PICATINNY LAKE DAM

PHASE 1 INSPECTION REPORT
NATIONAL DAM SAFETY PROGRAM

Picatinny Lake Dam (NJ-00002).
Passaic River Basin, Green Pond
Brook, Morris County, New Jersey.
Phase 1 Inspection Report.

CORPS OF ENGINEERS ASSESSMENT OF GENERAL CONDITIONS

Photo No. 1 - View of upstream face of dam and spillway. Note the oil barrier, headwater gage, and the 5" ϕ steam line and 4" ϕ air line passing across the spillway. The trash/fish screens are totally deteriorated, but deterioration of the spillway structure is surficial only.

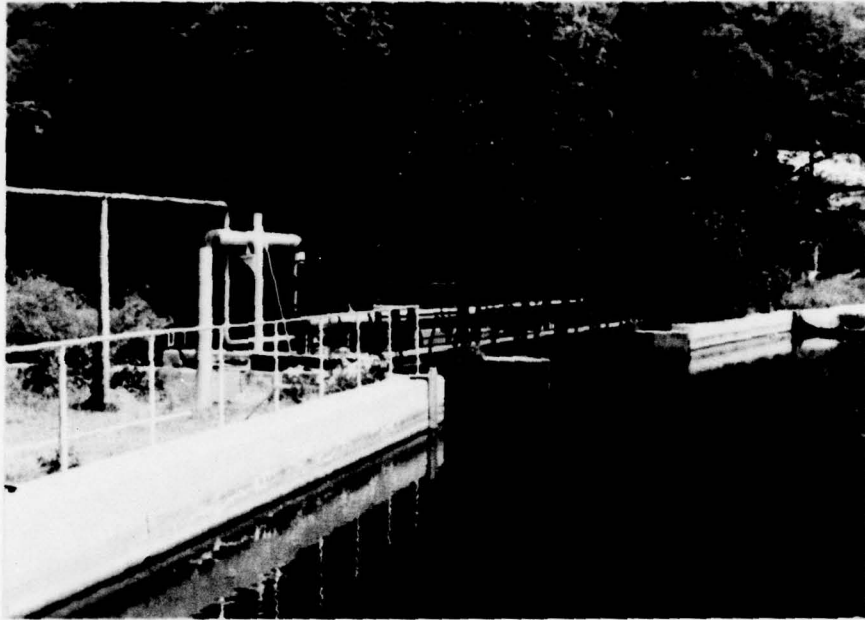
Photo No. 2 - View of downstream face of spillway. Note the minor deterioration on the submerged surfaces and the good overall condition.

Photo No. 5 - Detail of the footbridge over the spillway showing the surface deterioration, but good structural condition. The manual lifting devices for the flashboards are to the left of the bridge, and for the fishscreens to the right.

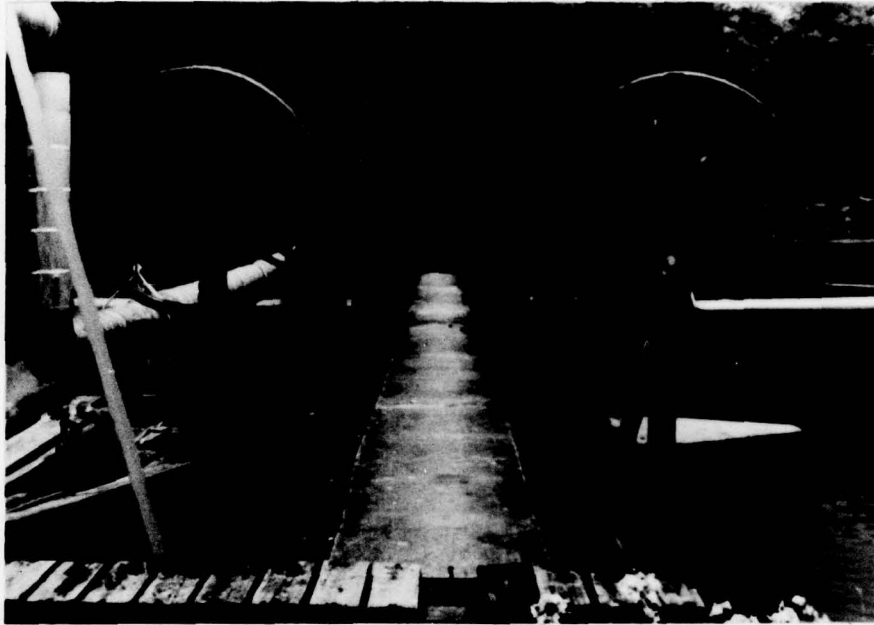
Photo No. 6 - Typical detail of a flashboard in the center section. The flashboard shown has been raised by 1/2 inch to permit discharge from the lake. Note the missing tension rod, the rusted condition of the guides and steel gate-parts, and the spalled concrete under the footbridge.
